## Attachment 4

### PLP Lake Powell Pipeline Project Responses to Participant Comments on PLP and Draft Study Reports

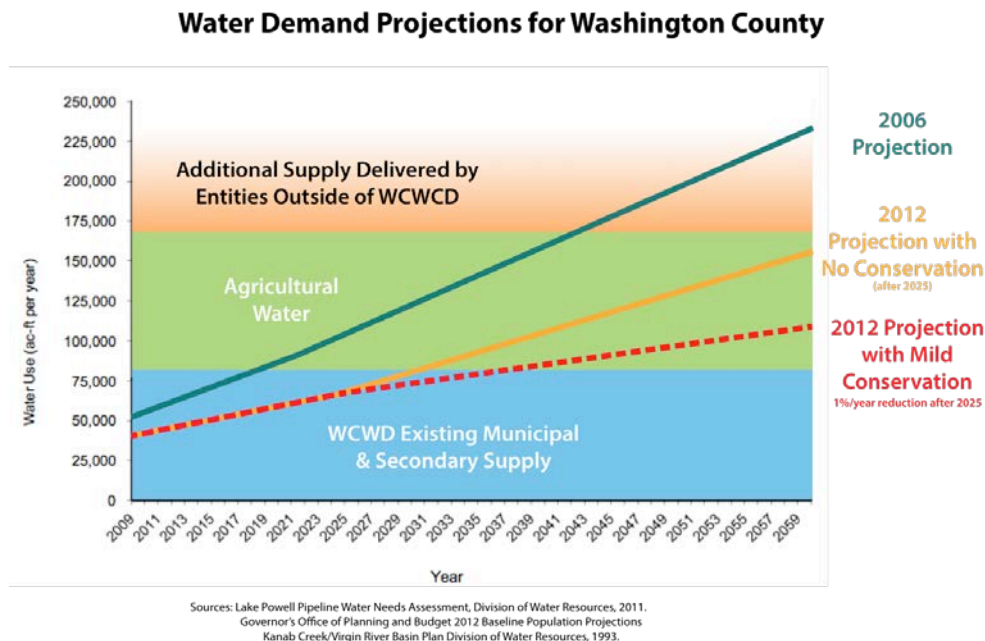
the year 2060, 32.4 percent lower than population projections made by the GOPB in 2005.<sup>1</sup> Since the District's water needs projections rely on these population projections, the more updated data pushes the supposed need for the LPP back over 12 years. The labeled 2006 Population and 2012 Projection with No Conservation lines in Figure 2 on page 3 illustrates the difference between these two different population forecasts on water use.

Figure 1: Per Person Water Use, Gallons per Day

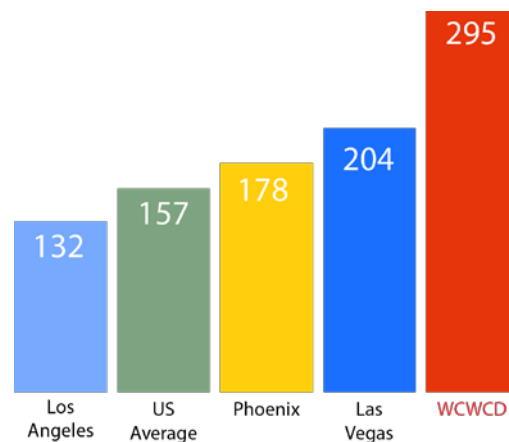
*Since WCWCD’s per person water use is nearly twice the national average, it is clear there is great potential for additional water conservation efforts.*

Figure 4: The WCWCD would be required to increase revenues substantially to cover annual LPP debt payments. Since WCWCD cannot raise taxes further, this increase in revenues would have to come from water rates and/or impact fees.

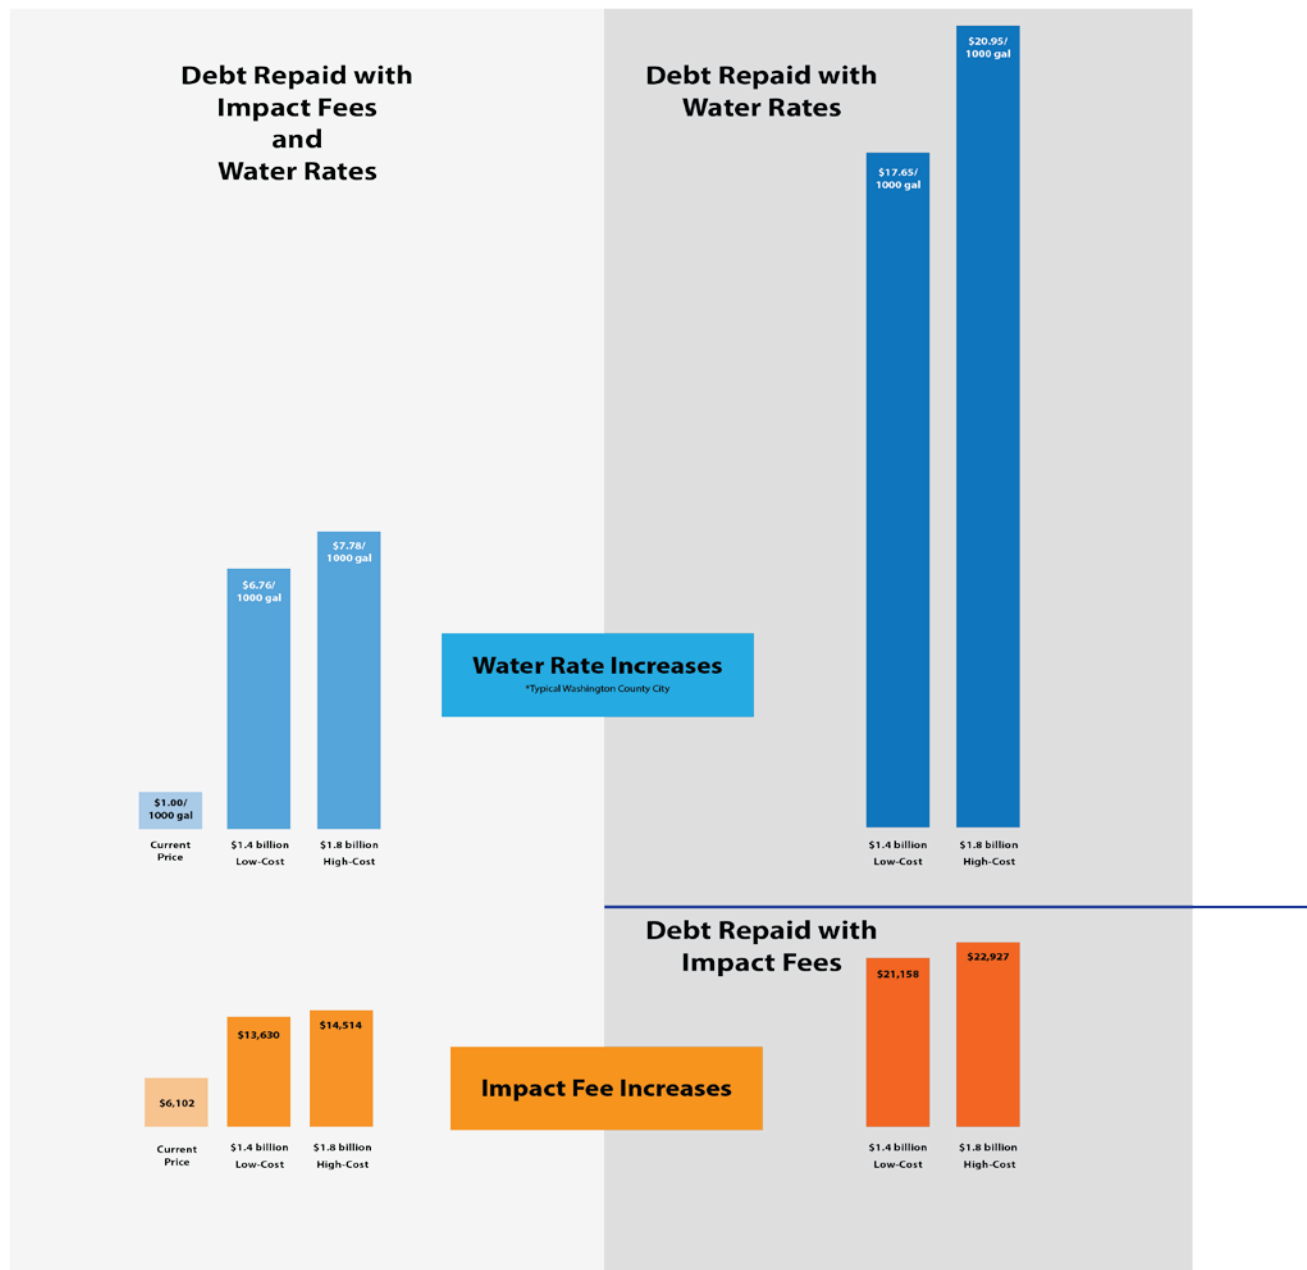
The right side of this graphic shows the increases required by WCWCD if they chose to only increase revenues from one source to repay the debt (cells B12 & B17). The left side of this graphic shows the increases required if WCWCD shifted the increases proportionally on the revenue sources (cells B20 & B22). The upper and lower parts of the graphic show the water price increases and impact fee increases required respectively.

*Figure 1. WCWCD's Supply and demand projections under Western Resource Advocates' revised No Action Alternative*

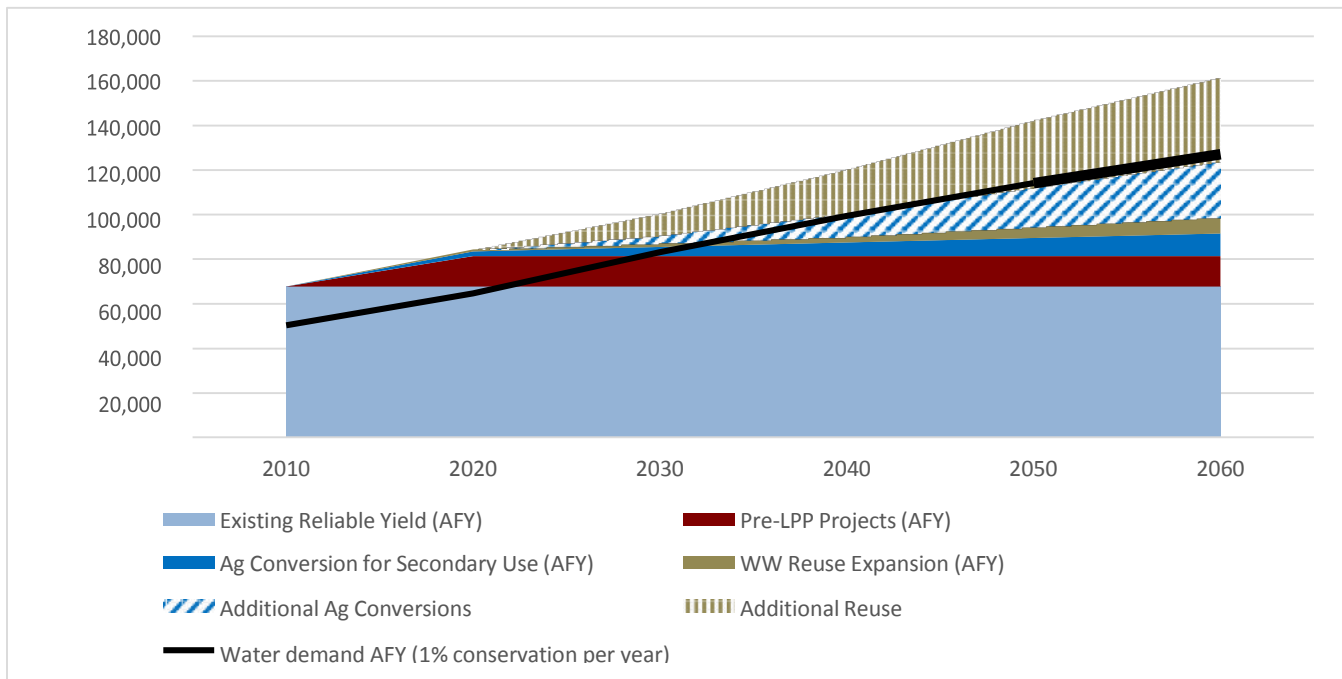
*For this comment letter, we revised parts of the Local Waters Alternative to reflect updated data from the project applicants<sup>2</sup> and to illustrate that our solutions remain viable. Figure 1 (below) shows updated data for Western Resource Advocates' No Action Alternative. We use many of the same water supplies as reported by WCWCD in Figure ES-2 of the 2015 Water Needs Assessment (2015 WNA): existing reliable yield, pre-LPP projects, agricultural conservation for secondary use, and the wastewater reuse expansion water. However, we do not include potable or secondary water from the LPP. In addition, we add in extra water resources from expanded reuse and expanded agricultural water conversions, as described below. Our population projection also matches the ones used in the 2015 WNA.*

**Figure 3. Historical and Projected Supply, Use, and Demand**

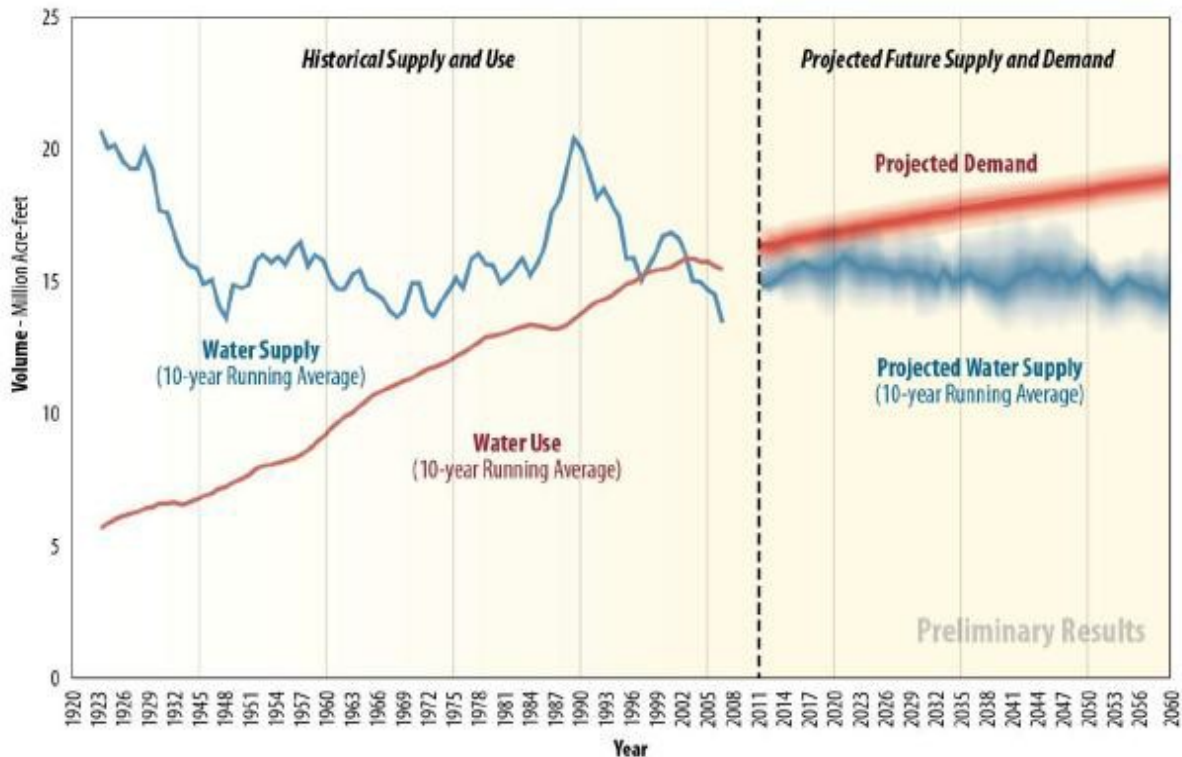
*The red line represents the water supply and the blue line represents water demand. Figure 3 illustrates clearly that a supply and demand imbalance currently exists in the Basin. This imbalance will grow in the future if major changes are not made in how we use water.*

Figure 4. Lake Powell Projected Elevations

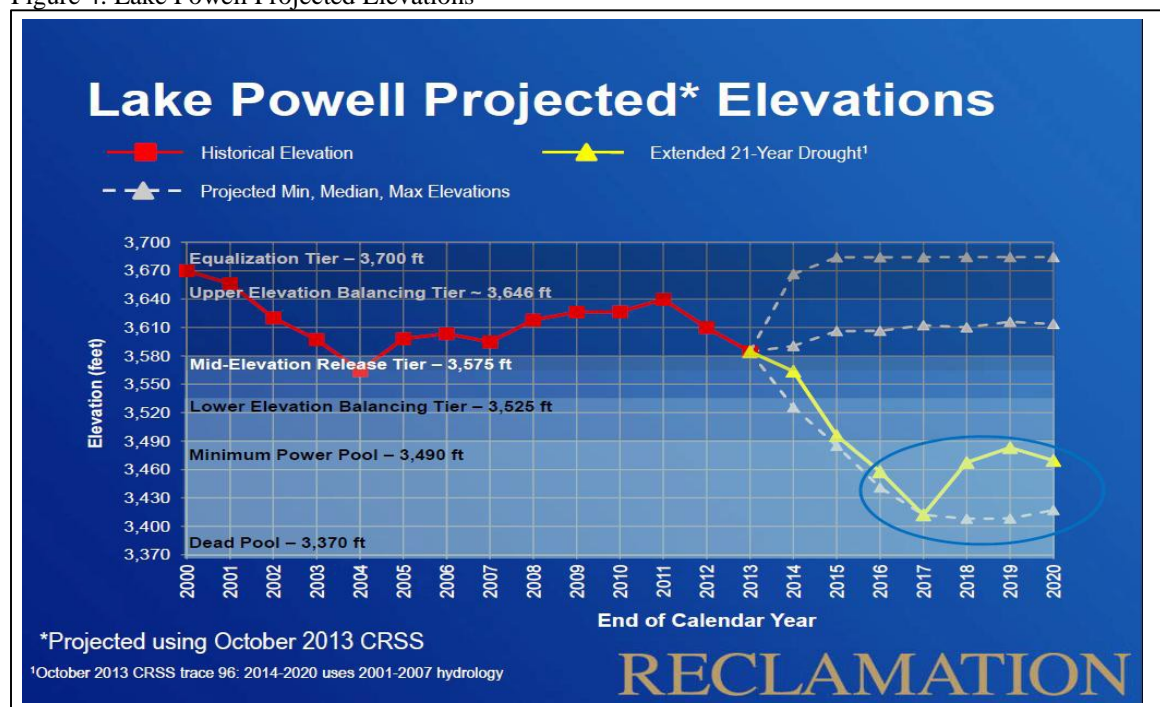
*On the contrary, a Bureau of Reclamation chart, Figure 4 (below), shows that if the drought continues from a fifteen year to a twenty-one year drought, the elevation of Lake Powell could fall below the minimum power pool level.*

**Figure 6. Glen Canyon Dam Penstocks at Minimum Power Pool 3490 msl**

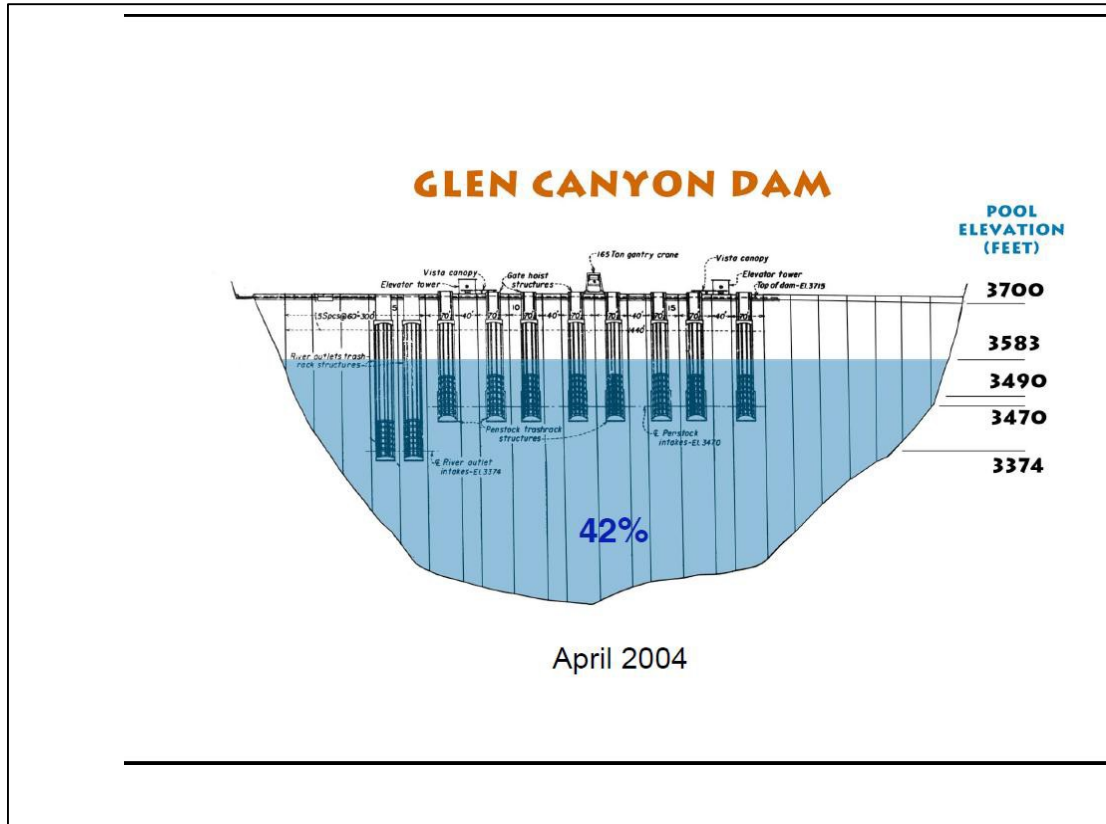
Figure 6 illustrates the minimum power pool elevation in Lake Powell at 3490 feet msl.

The Project's second intake is at 3474 msl in Lake Powell, which is 16 ft. below minimum power pool elevation in Lake Powell.

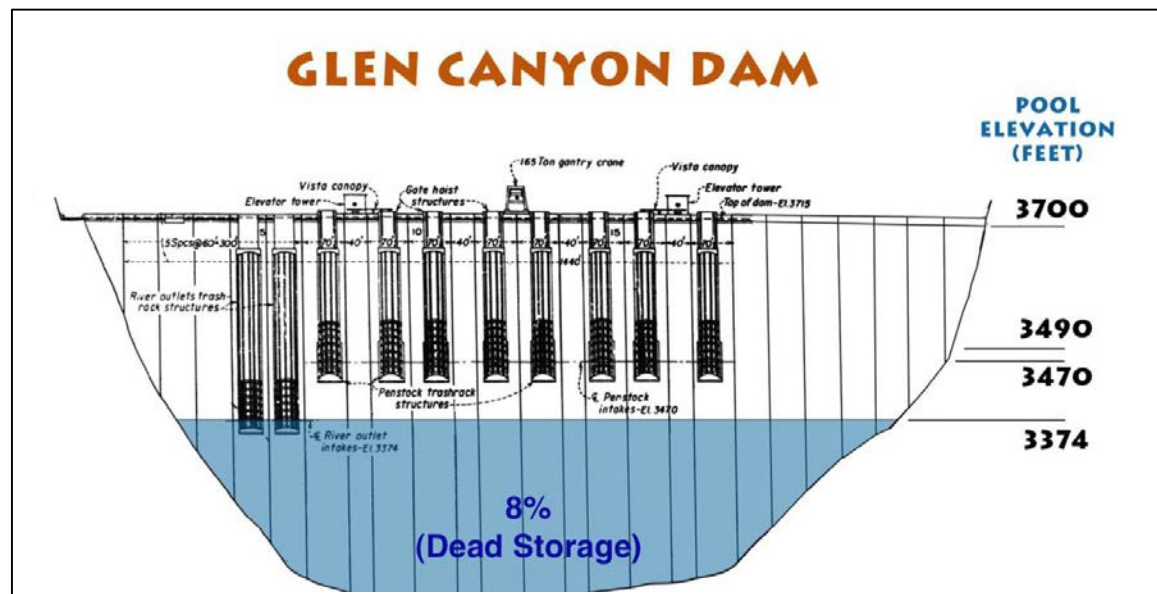
The third intake is at 3375 msl, which is 5 feet above dead pool in Lake Powell.

**Figure 8. Per Capita Use Washington County**

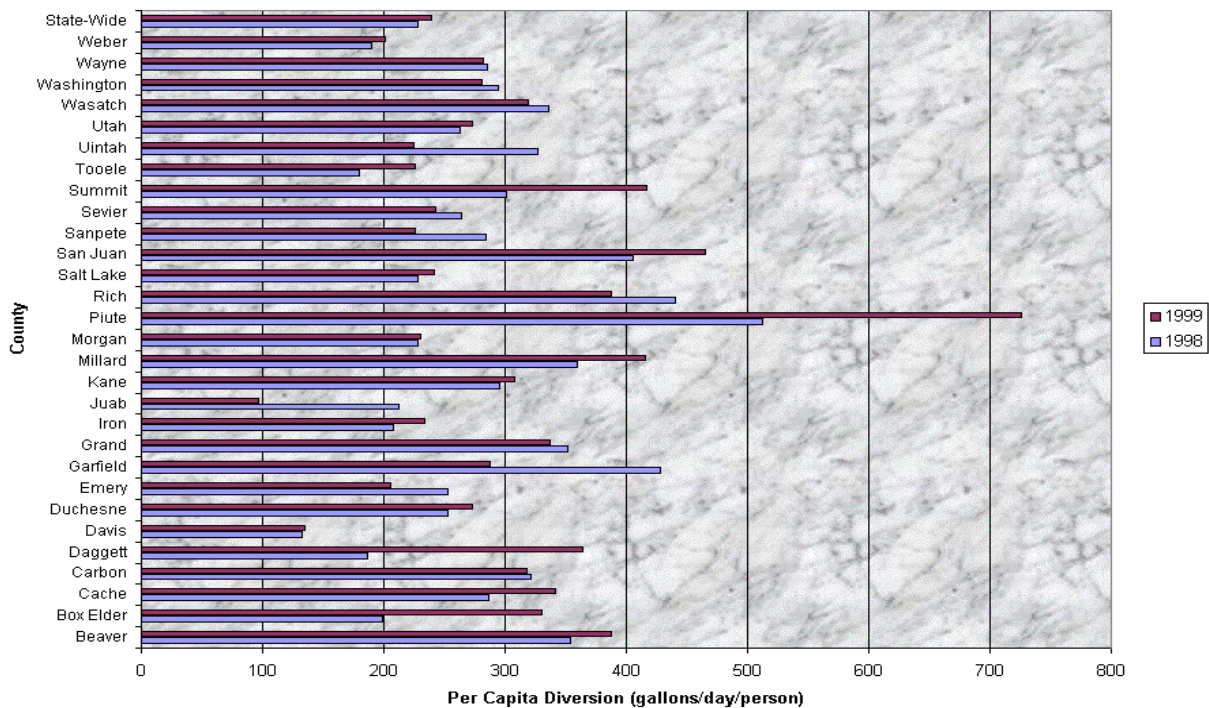
*Additionally the Division of Water Rights in its 2000 water report indicates the gpcd was less than 300 gpcd. See Figure 8 below.<sup>74</sup>*

Figure 2: GPCD calculated using 6 cities estimated population

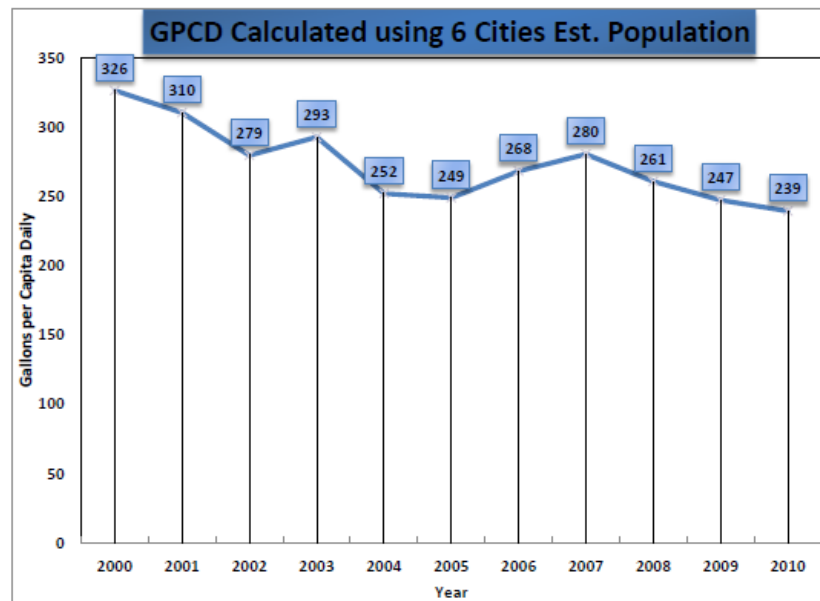
Although the chart is for six cities only, are we to believe that including other WC areas would really raise the 2000 usage from 325 gpcd to 439 gpcd and the 2010 usage from 239 gpcd to 325 gpcd? With WCWCD asserting that our 2013 usage was 270 gpcd, if true, and their own Figure 3-1 showing 325 in 2010, their conservation measures are apparently going in the opposite direction than they should. This 1996 conservation plan (revised in December 2010) has been replaced by a new 2015 conservation plan. The new 2015 Conservation Plan shows 325 gpcd as the 2010 figure. Since the chart above used "estimated population" to compute the

Figure 3-1. 2010 Gallons Per Capita Per Day (GPCD) Water Use\*

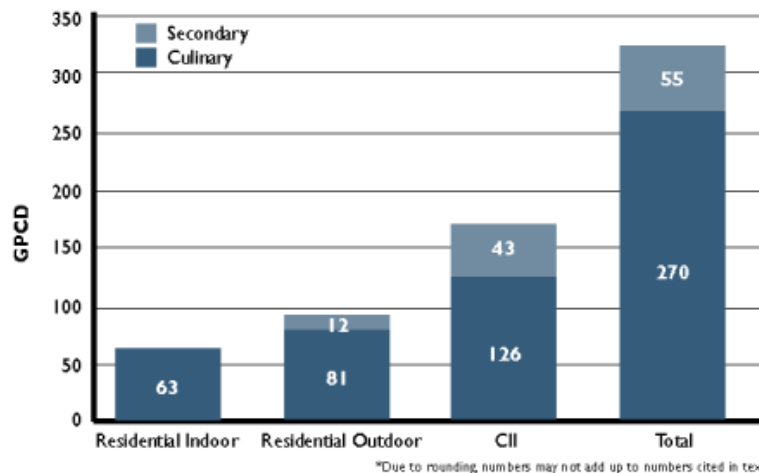
Using the 2015 WNA and Maddaus figures, a 12% reduction from 2010's 325 gpcd by 2060 would still keep us at 286 gpcd, which could be challenging for the reduced supply they assert. However, for the state to assert that 23% reduction in supply would be too onerous given our current real usage is without merit. If we were to reduce our current usage by 23% to meet the supply reduction, that would put our usage at 208 gpcd, which is completely reasonable and yet still above what other desert cities are using now.

**Figure 3-2: 2010 Water Consumption by user group**

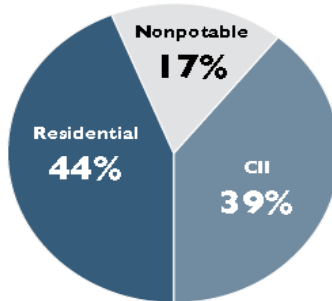
*Figure 3-2 shown in the WCWCD's Water Conservation Plan on their website (updated December 2015), Page 12, shows the district's CII usage at 39%. However, if the Secondary usage on the chart 17% is added to that, the total comes to 56%. As noted in the above paragraph dealing with the Maddaus report, their chart shows Secondary at 17% and is clearly part of the district's CII usage. Notes that accompany the WCWCD's Water Conservation Plan state:*

**Figure 3-1. 2010 Gallons Per Capita Per Day (GPCD) Water Use\***

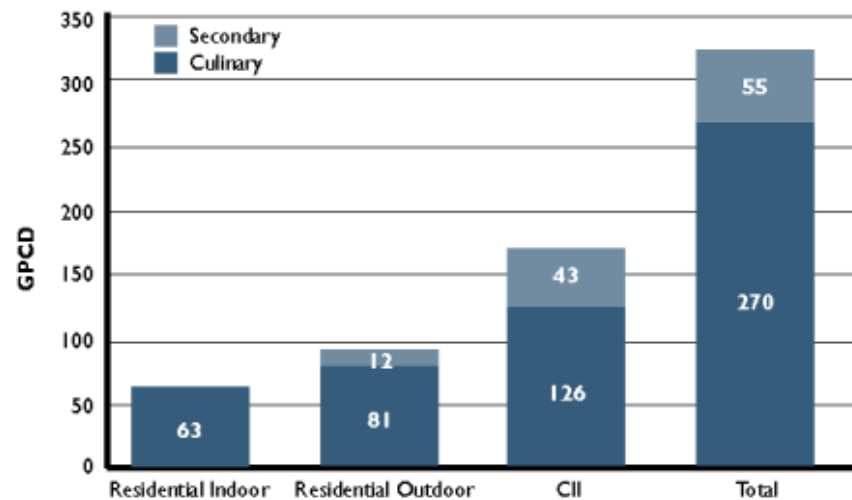
*Additionally, this chart from the WCWCD’s “Water Conservation Plan” (Dec. 2015) – same as Figure 3-1 (page 3-2) in the WNA – adds to the confusion by showing CII at 43 (secondary) and 126 (culinary), which comes to 169 or 52% of the total 325 gpcd. This is off from the 46% and 39% shown in table above, and even “rounding numbers” (as noted in comment below the chart) doesn’t make up the difference.*

**Figure 7. The price structures of water in St. George, Santa Clara, and Hurricane UT are relatively flat and do not send a price signal to customers when they use excessive amounts of water. This is in contrast with a conservation oriented rate structure, like in Tucson, AZ.<sup>32</sup>**

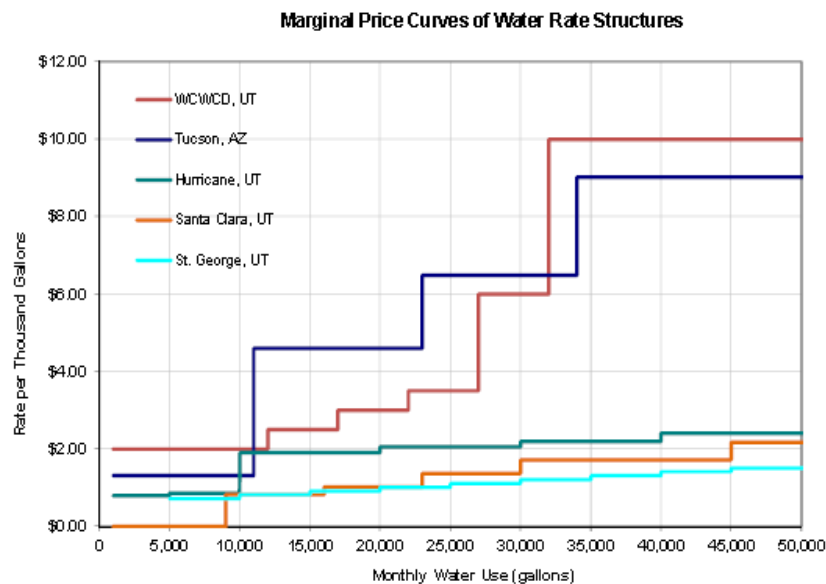
Rate structures in WC to encourage conservation are taken compared to what other areas have in place to encourage conservation of water. The following charts are from reports completed by Western Resource Advocates. The chart “Marginal Price Curves of Water Rate Structures” on the following page is from WRA’s 2012 “Local Waters Alternative to the Lake Powell Pipeline.”
